RE: New York SMSA Limited Partnership d/b/a Verizon Wireless Special Permit and Site Plan Application to Install a Public Utility Personal Wireless Facility at the Property Known as 52 Montrose Station Road, Town of Cortlandt, NY

Specifically, the redesigned Facility and the documents submitted herewith respond to the comments raised by the Town Engineer and Town RF Consultant as follows:

Response to the Comments from Town Engineer:

Cortlandt
 52 Montrose Station Road
 Cortlandt, NY
 41 16 11.15 N
 73 53 48.26 W
 Antenna Centerline: 137' AGL
 Ground Elevation: 410' 6" AMSL

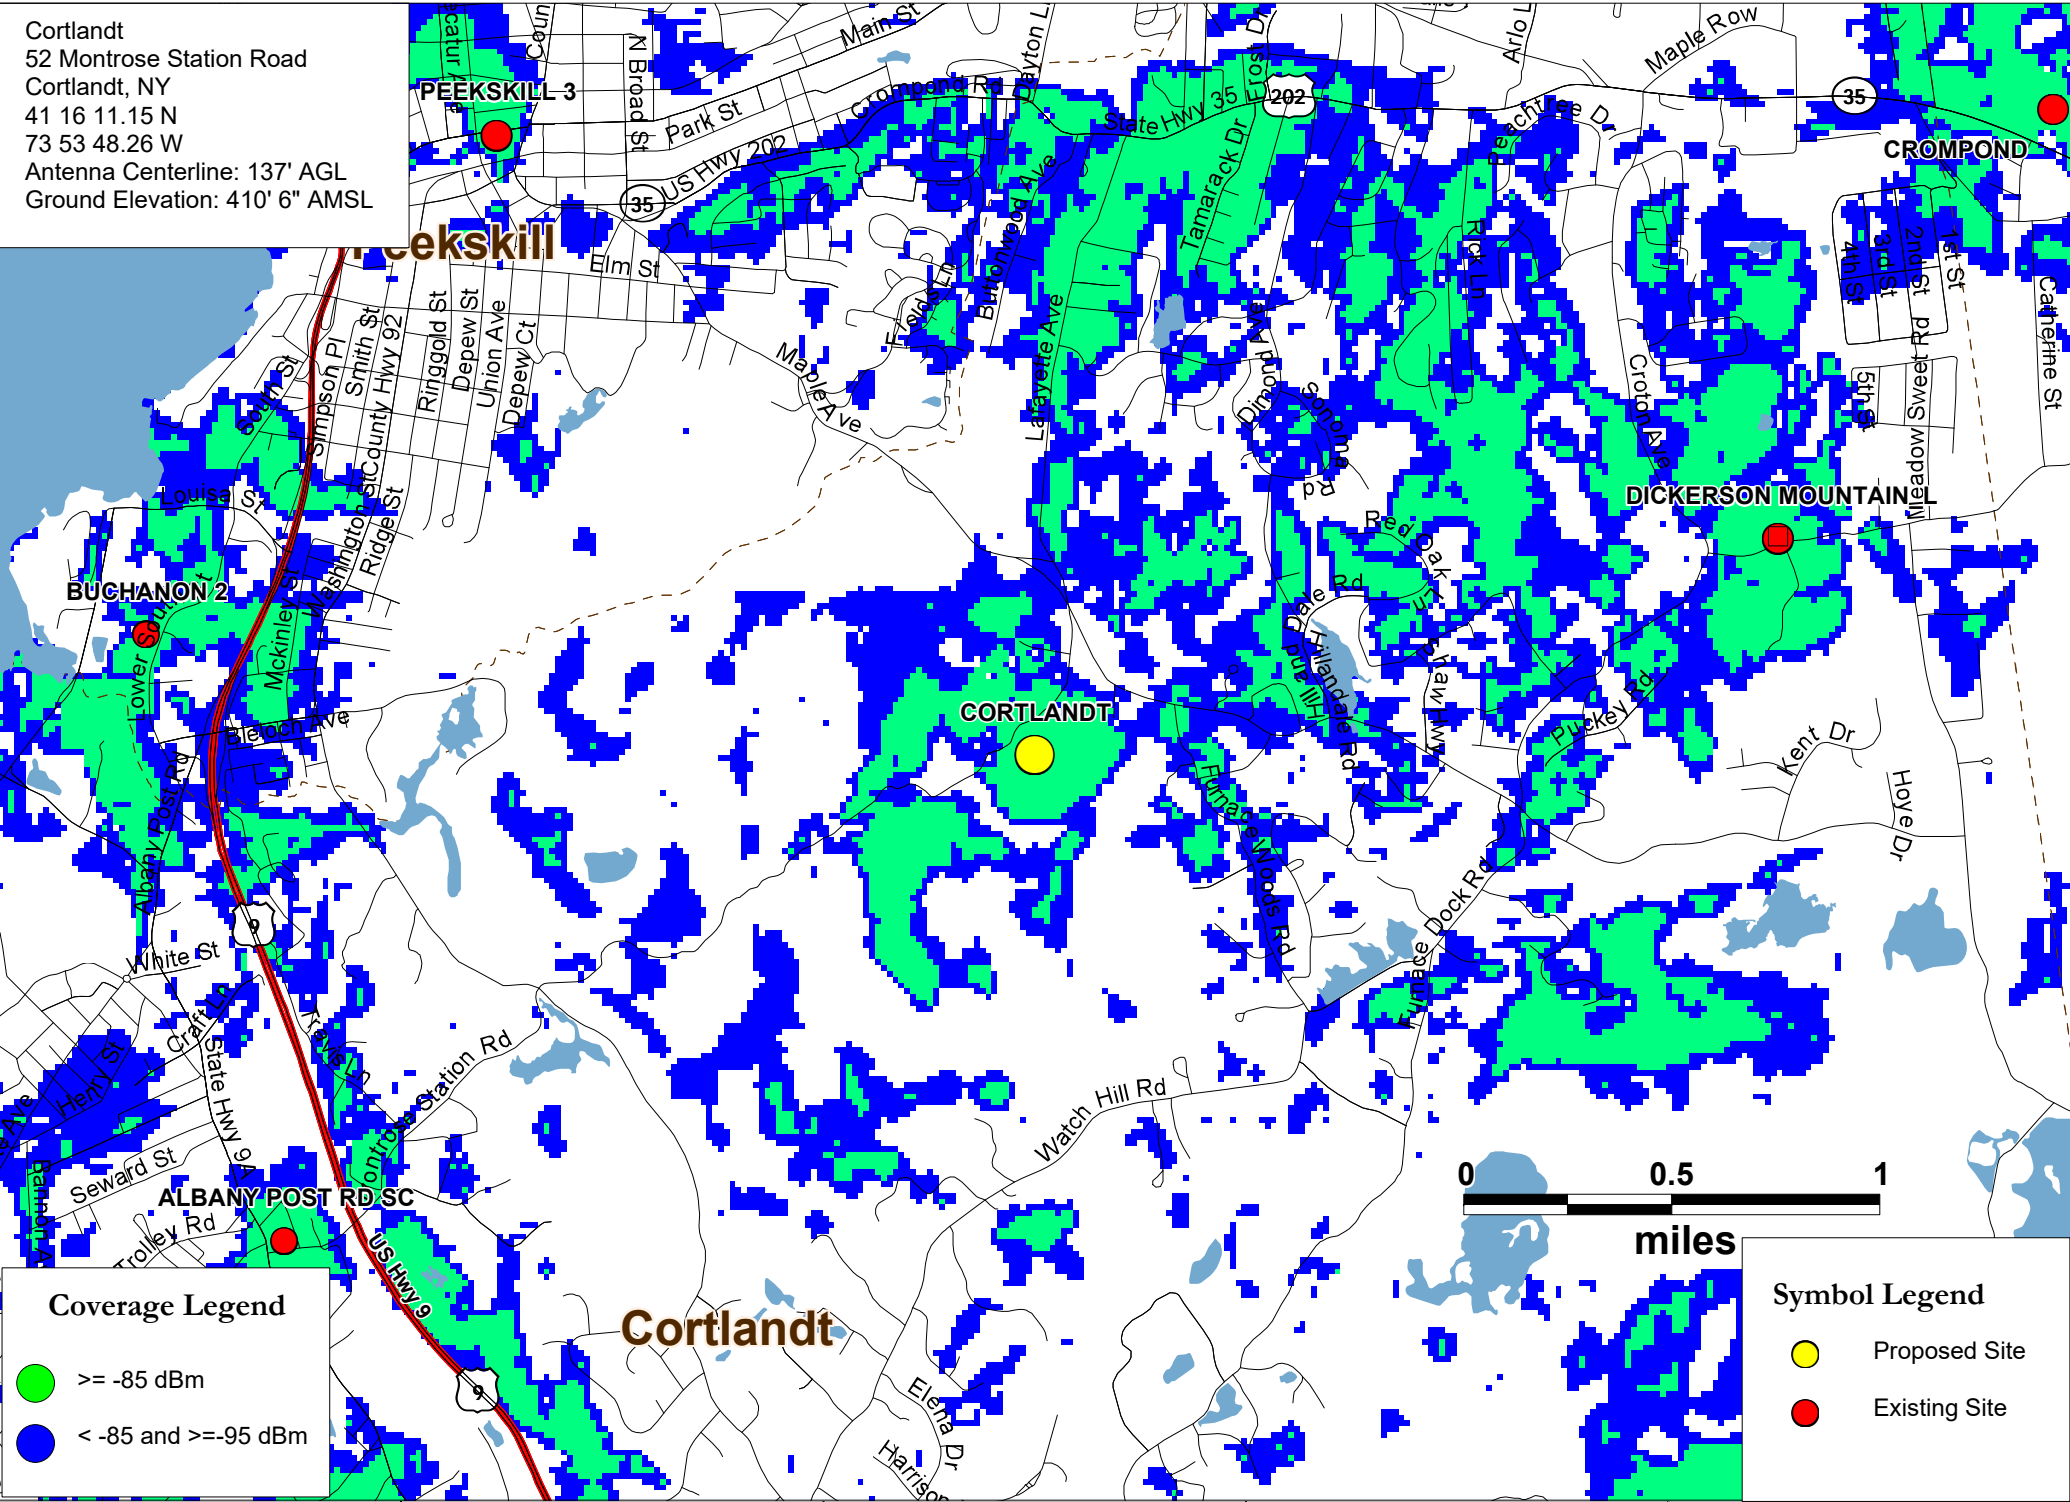
Town Consultant Comment: *The applicant has submitted supplemental material that contains a Supplemental Report (C Squared Systems, LLC, dated 8/16/19, signed by Martin Lavin) and signal propagation maps to demonstrate Verizon Wireless service at the proposed location. The supplement report and maps provided show only 750 MHz service and show required signal strength for reliable in- building and in-vehicle service for 750 MHz frequencies at -85 dBm and -95 dBm, respectively. As noted above and as discussed on the conference call, we recommend that Verizon submit separate propagation maps for all frequencies that it is authorized to operate in this area, showing all existing and proposed coverage from all adjacent sites. Drive test data should also be provided to confirm service deficiency. To confirm the accuracy of the data and maps provided, we require the applicant to complete the attached Propagation Data Study Sheet and attest to the maximum power being utilized for the maps. INCOMPLETE.*

Response: Attached hereto as Exhibit A are revised maps showing the proposed coverage from the Site at its new proposed location in the 750 MHz frequency band, which provides the most geographic area, and the 2100 MHz frequency band, which provides the least geographic coverage area. Therefore, with both of these bands in the C Squared February

Report, the best and worst scenarios were presented. As the need for coverage in the 750 MHz range has been established, there is no need to show the coverage area from the higher frequencies (i.e 850, 1900 MHz), which would be smaller geographically and fully encompassed in the proposed 750 MHz coverage.

EXHIBIT B

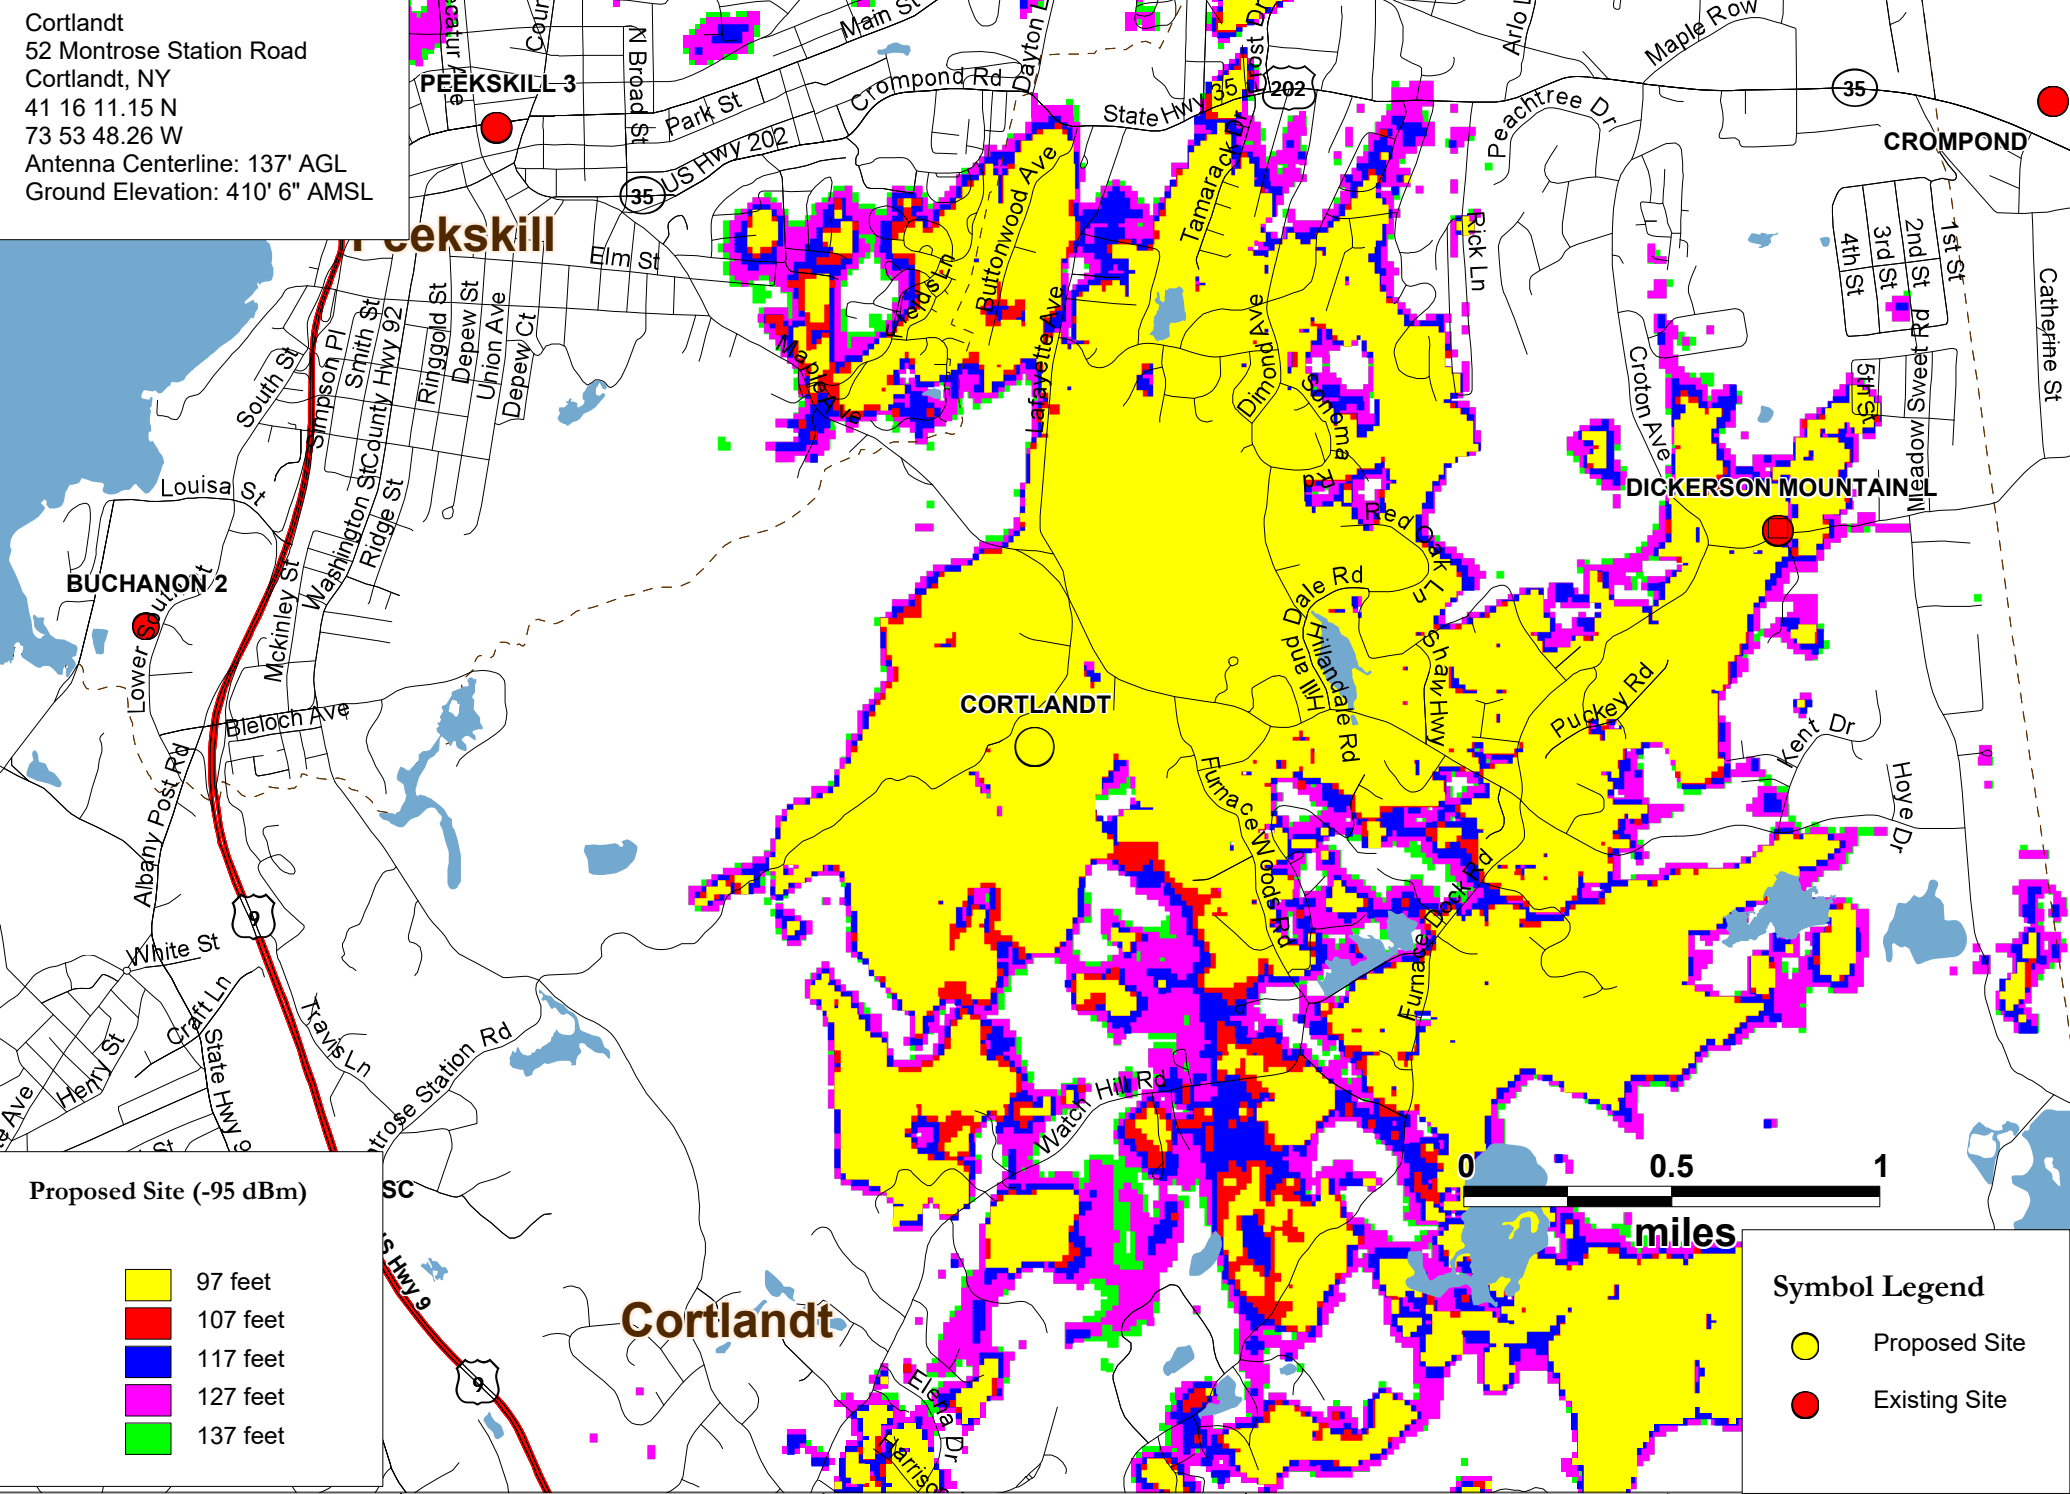
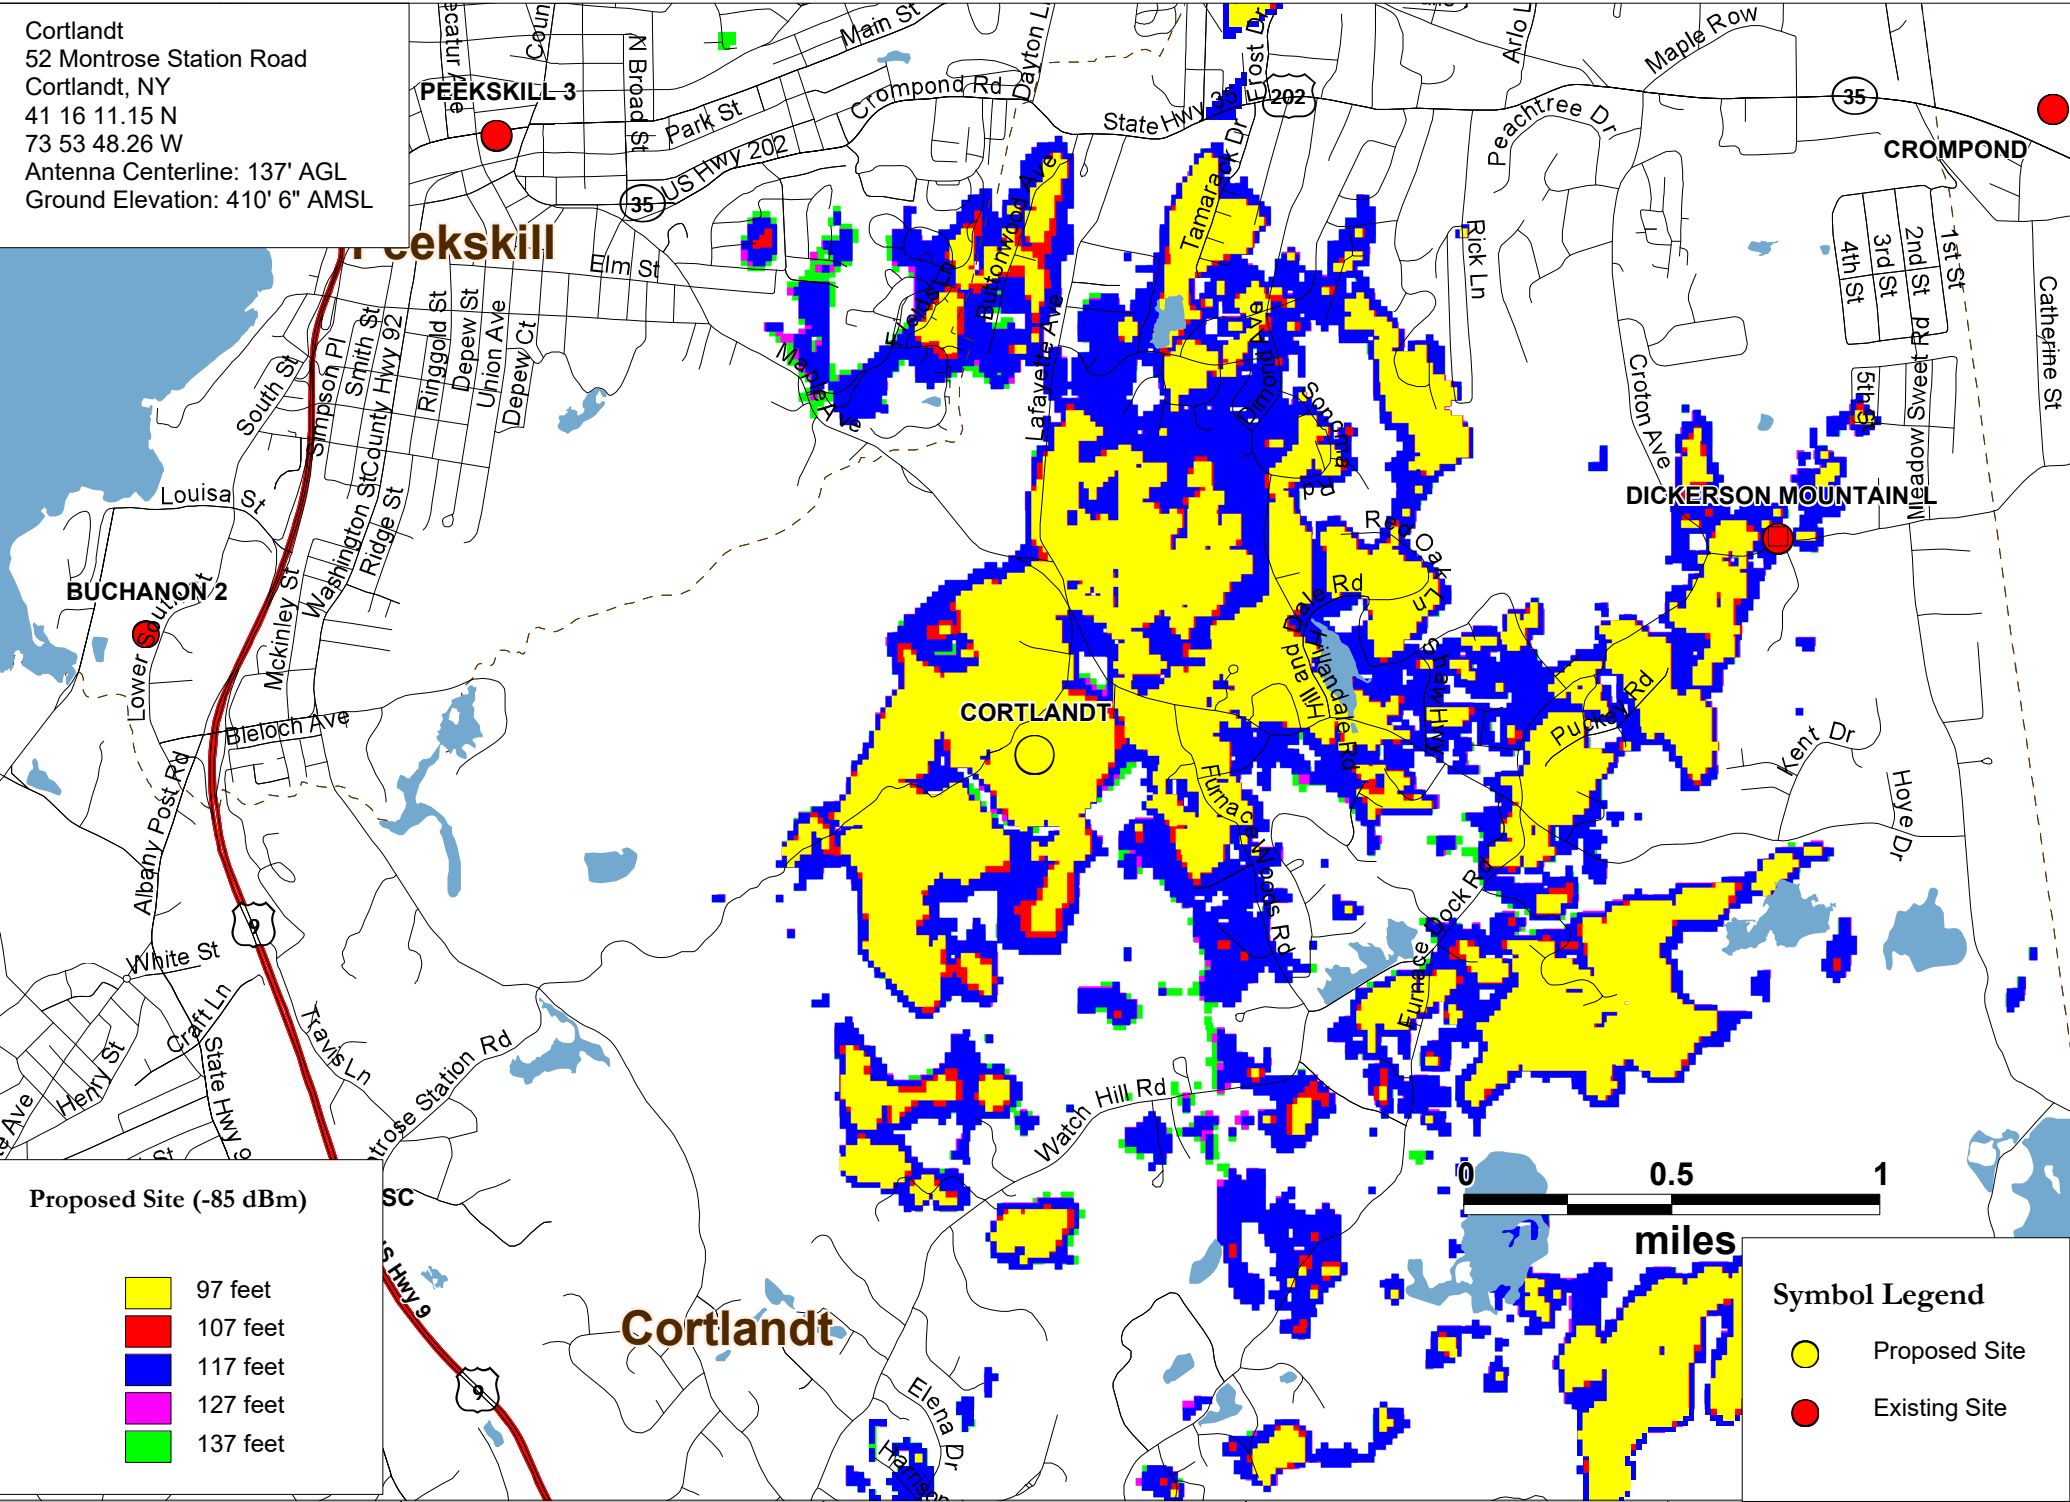
Town Consultant Comment: *Attached as Exhibit B to the C Squared Supplemental Report are coverage maps showing the differences in coverage at varying heights (97', 107', 117', 127' and 137'), one at -85 dBm and one at -95 dBm, which show that coverage decreases as the heights get lower. Upon review it appears that the difference in coverage is minimal between the different heights and a structure height of 100' would satisfy the proposed need. However, addition drive test data and detailed capacity data has not been submitted to confirm the need for the proposed new facility. INCOMPLETE*

Response:

As noted above, the revised location of the proposed tower is over 30 feet lower in ground elevation than the originally proposed location, even though the tower is the same height above ground level. Any further reduction in height would limit Verizon Wireless' coverage even further and greatly reduce the likelihood that collocators would be able to occupy this tower.
